# REQUEST FOR ACTION CHASKA PLANNING COMMISSION 4/8/2026

Subject: The Inn – PSB, REZ, and VAC

Applicant: Community Asset Foundation

Synopsis: The applicant is requesting approval of Preliminary Site and Building Plans, Rezoning, and an Easement Vacation for The Inn, a four-unit dwelling, at 1201 and 1207 Yellow Brick Road

Figure 12: Easement area

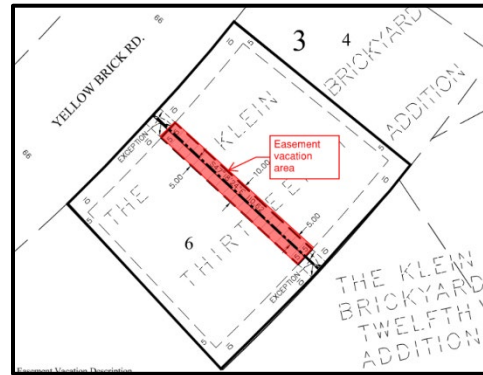
The applicant has requested vacation of the existing drainage and utility easement located along the shared property line. Staff supports the request as the easement, as the easement does not contain public infrastructure and would become obsolete once the properties are combined<sup>4</sup>.

<sup>4</sup> Included as a condition of approval: The vacation is contingent on the combination of the properties being recorded with Carver County.

Figure 14: Creek Run Townhomes Landscaping Plan

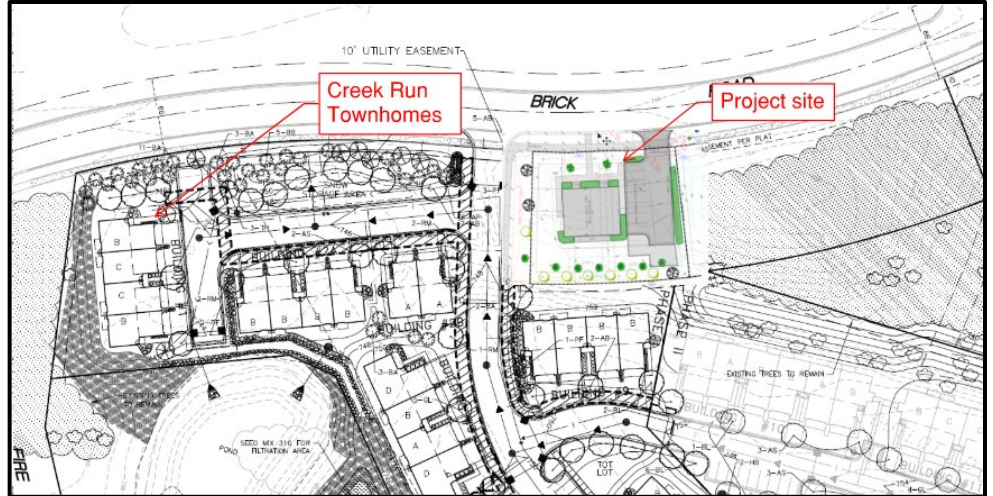
The existing Creek Run townhomes to the west and south range in height from 20 to 23 feet. However, the townhomes are setback more than 40 feet from Yellow Brick Road and are heavily screened with vegetative berms.

Staff recommends maintaining the 20-foot height limit unless additional screening and vegetation, more consistent with Creek Run townhomes, is proposed. Both of these options provide a reasonable transition from the townhomes to the single-story homes.

Figure 16: Illumination Plan

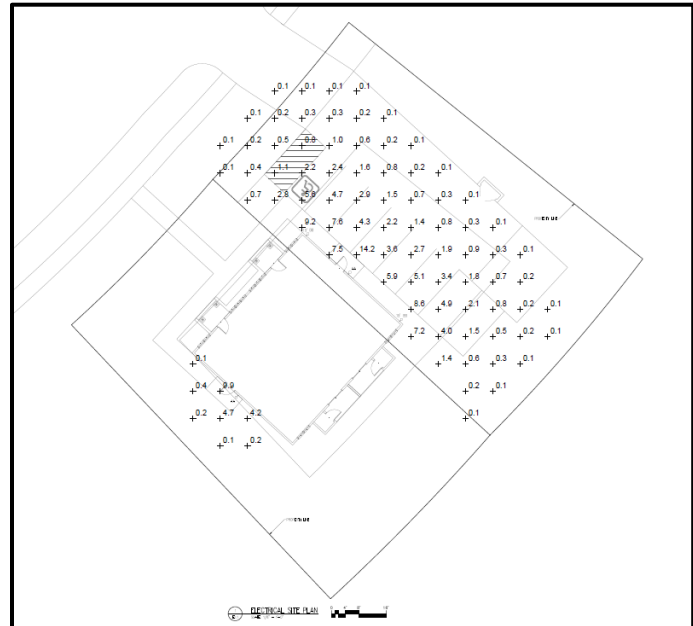
Based on staff's review of available details, it's likely the illumination plan meets requirements. However, additional details are required for confirmation:

- Plan notes include the code "MWP10" but without additional information, staff is unable to ensure the lights are shielded and down casted with a cut-off angle of less than 70 degrees.
- The illumination plan must include points across entire property.

These items have been added as conditions of approval and will be addressed during final review.

- f. Illumination plan,
    - i. Wall pack information to ensure cut-off angle of less than 70 degrees.
    - ii. Heights of all proposed luminaries.
    - iii. Points across the entire property (to the property line).

Figure 19: Preliminary Utility Plan

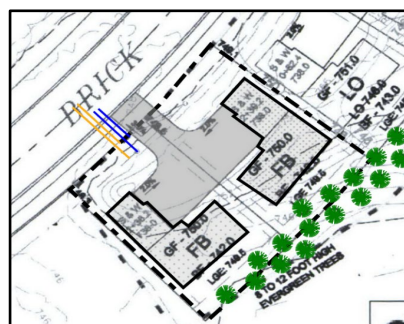
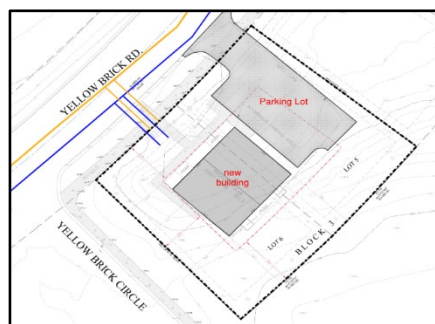
proposed preliminary utility plans shift the connections further east on the site to allow for future extension to properties located to the east.

Staff continues to support the driveway location and generally supports the utility connection locations. However, additional details will be required for final plan review to ensure the connections are suitable and would not disrupt access to the site for construction and maintenance.

The plans currently show utility connections within a 10-foot drainage and utility easement along the front property line. Staff notes that this easement is insufficient to accommodate long-term maintenance needs. The City typically requires easement widths of 30 feet for sanitary sewer and 20 feet for water mains. Staff will work with the developer ahead of final plan review to determine the appropriate easement width. This easement will need to be shown on the plans.

Figure 24: Landscaping Plan

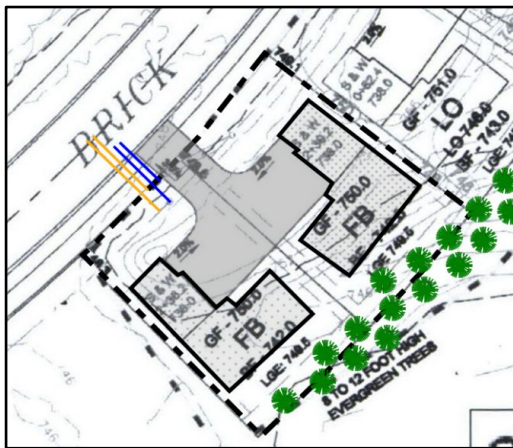
The approved BRICKYARD 13<sup>TH</sup> ADDITION landscaping plan included evergreens, 8-10 feet tall, spaced approximately 15-20 feet on center along the southern property line. The proposed plan is generally consistent, including a mix of 8-foot-tall Black Hills Spruce and Colorado Blue Spruce planted approximately 12 to 15 feet on center. The plan also includes replacement of the two deceased off-site trees located along Yellow Brick Circle.

Additional landscaping includes two crabapple trees along the front of the building, arborvitae planting to screen the parking lot, and foundation plantings around the building consisting of a mix of honeysuckle, juniper, and spirea.

**LANDSCAPE PLAN**  
SCALE: 1" = 20'-0"

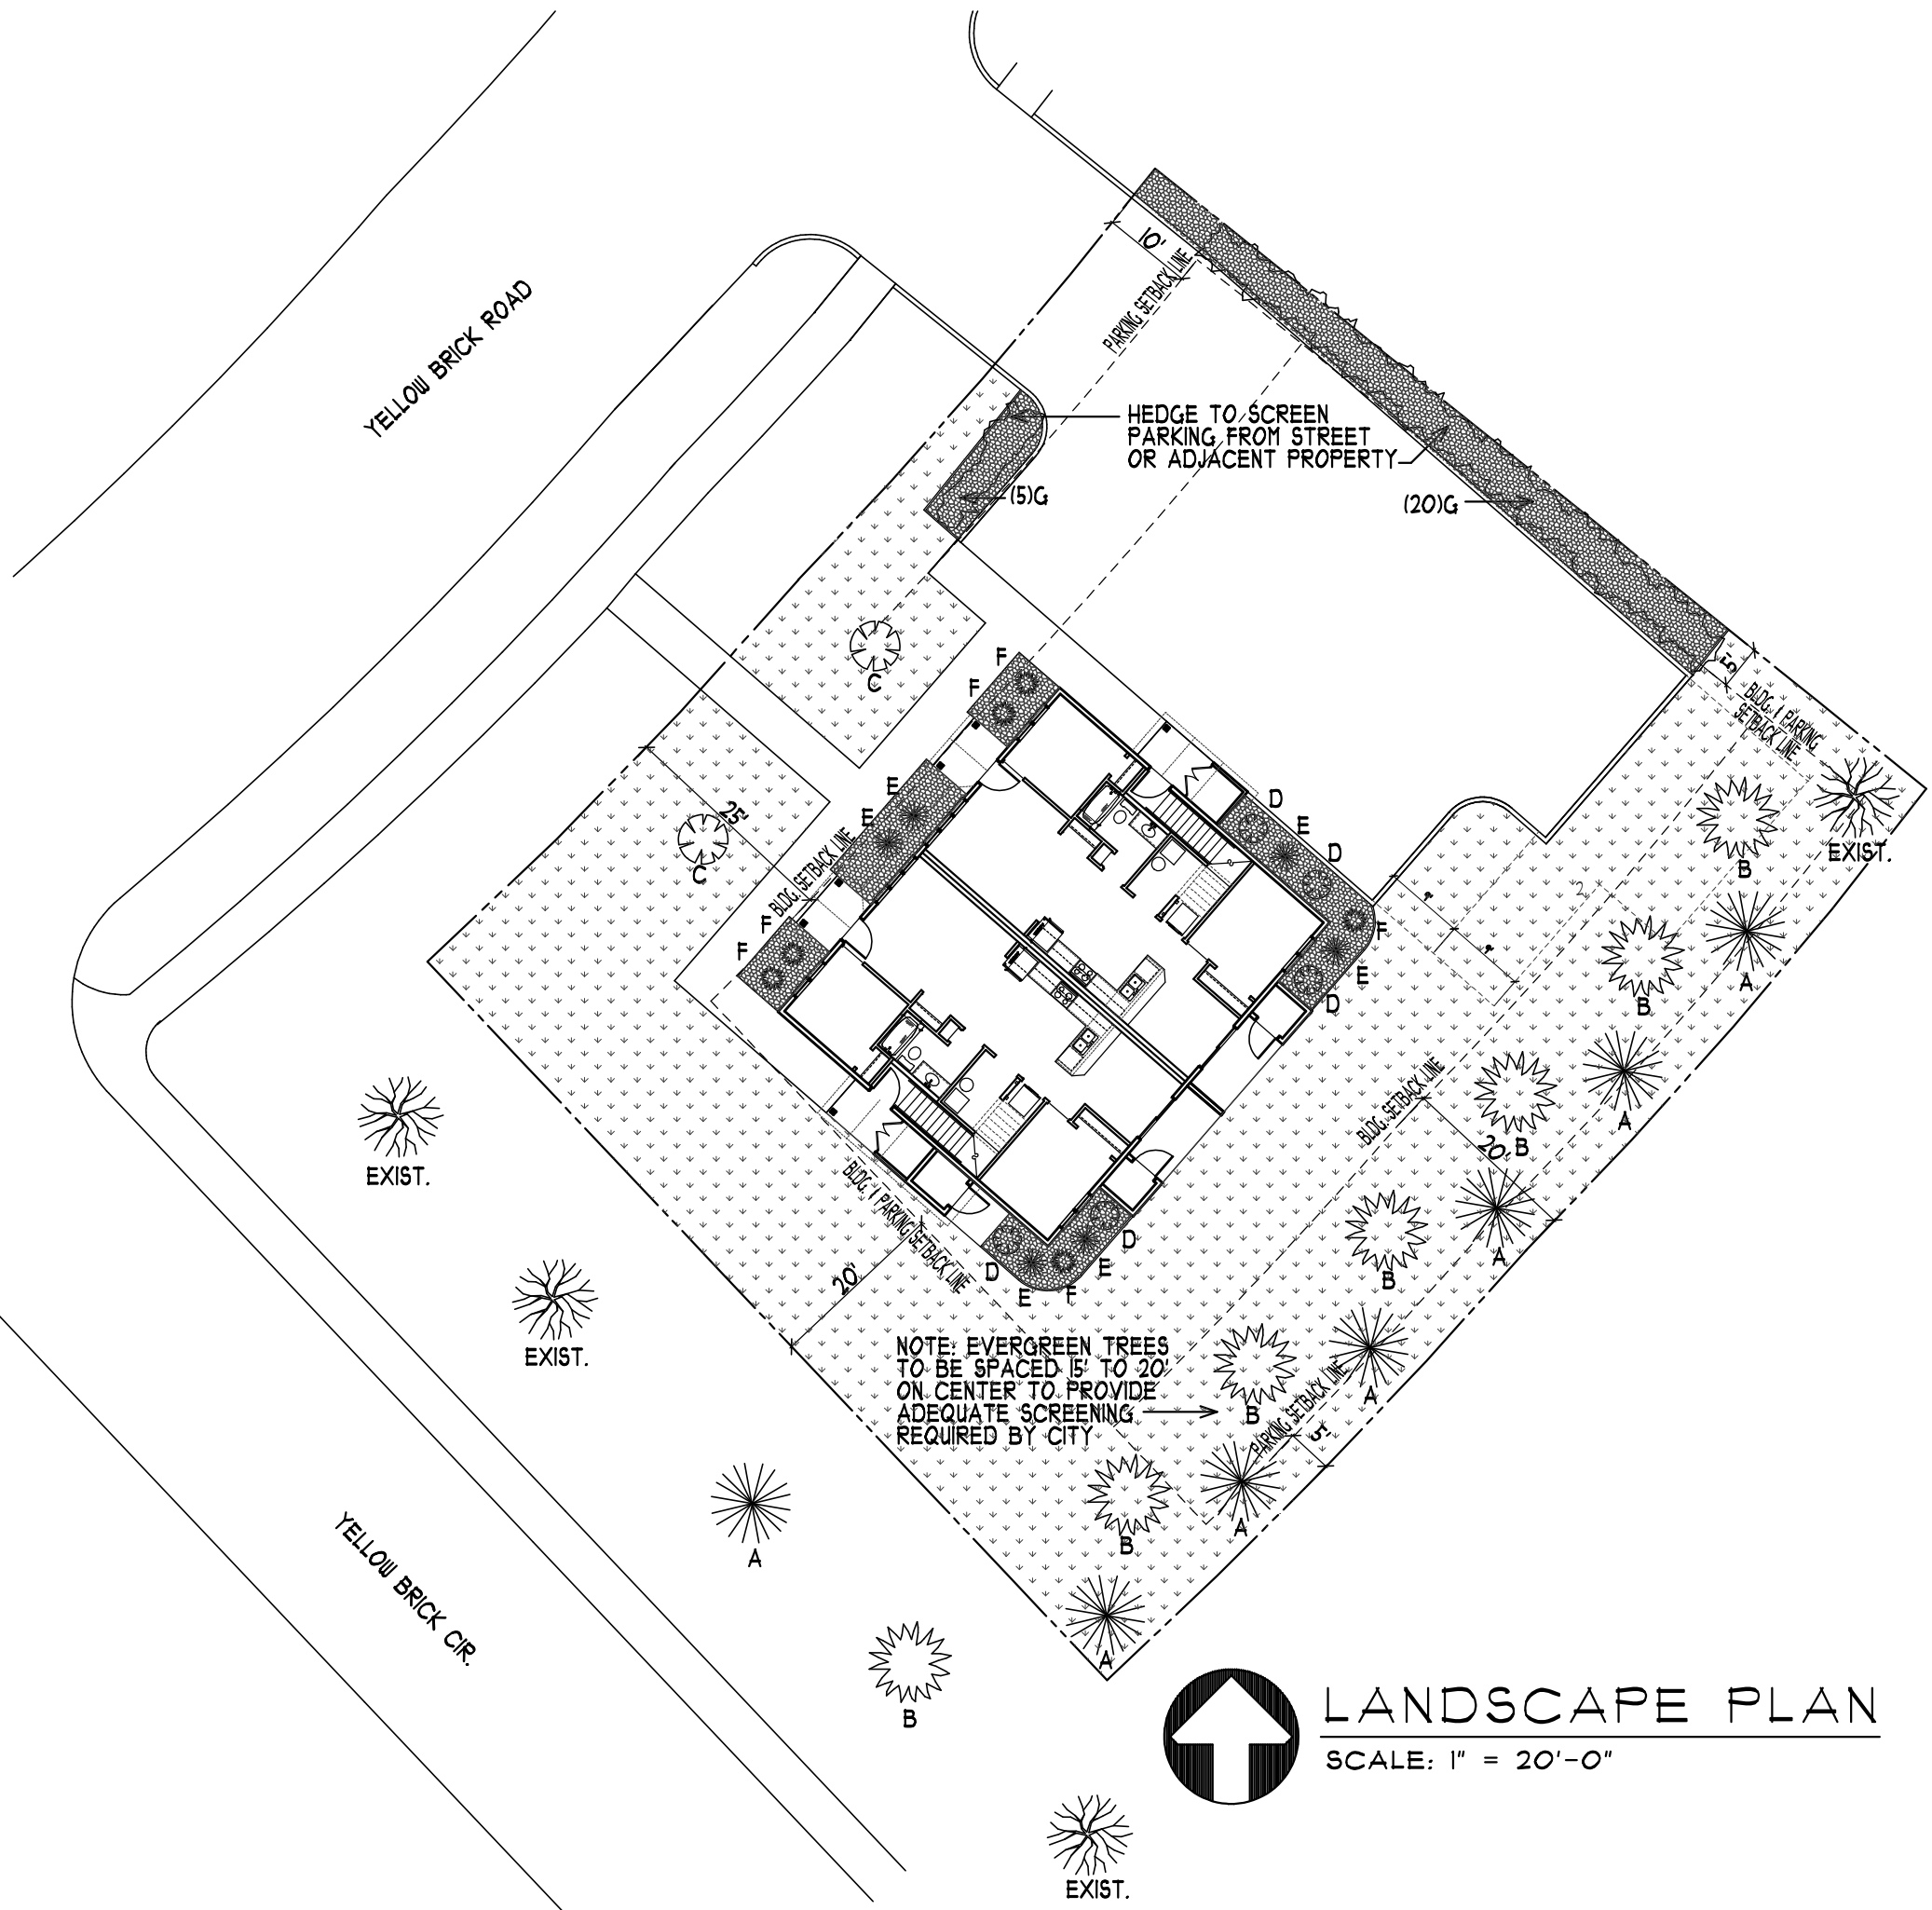
The developer is proposing 2-gallon, [Emerald Squeeze Arborvitae](#), spaced 42-inches apart, to screen the parking lot to Yellow Brick Road and the properties to the east. Staff is concerned that this planting will not provide sufficient screening, as this cultivar is slow-growing and generally columnar. For context, generally with proper soil conditions the cultivar is anticipated to reach full maturity at 20 years and be 8-feet tall by 4-feet wide. For perspective, the plants shown in Fig. 22 are 25-gallon shrubs.

Staff would support the reduced setback from Yellow Brick Road if enhanced screening is provided. Additional visual exhibits demonstrating effective screening will be required for final plan review<sup>13</sup>.
